TE Connectivity

Product Change Notification: PCN-22-143834

DIN 1.5 MM Socket Plug Connector, 5-7 POS. / DIN 2.5 MM Socket Plug Connector, 2-4 POS.

Before:

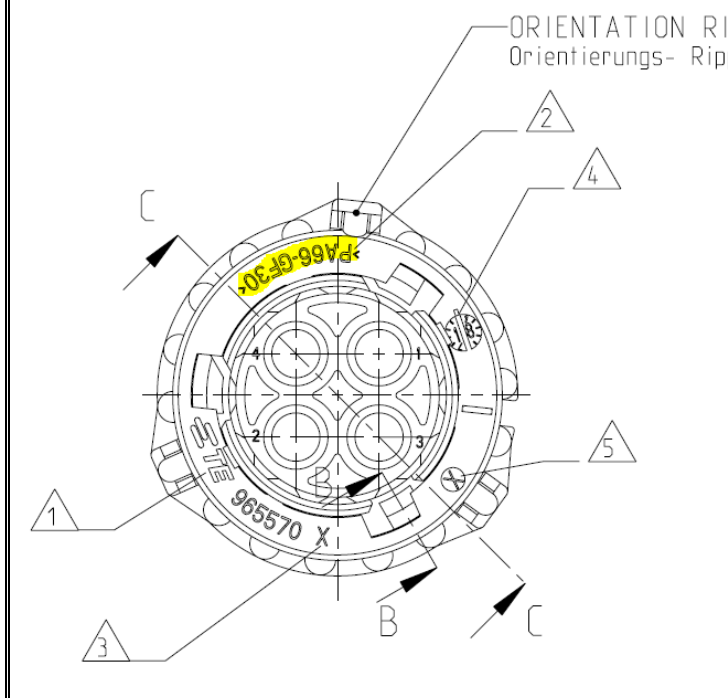
The Industrial and Commercial Transportation business unit of TE Connectivity is making a drawing change to document the use of PBT-type material for the coupling ring component used in EMEA assembly region for the product drawing(s) listed below.
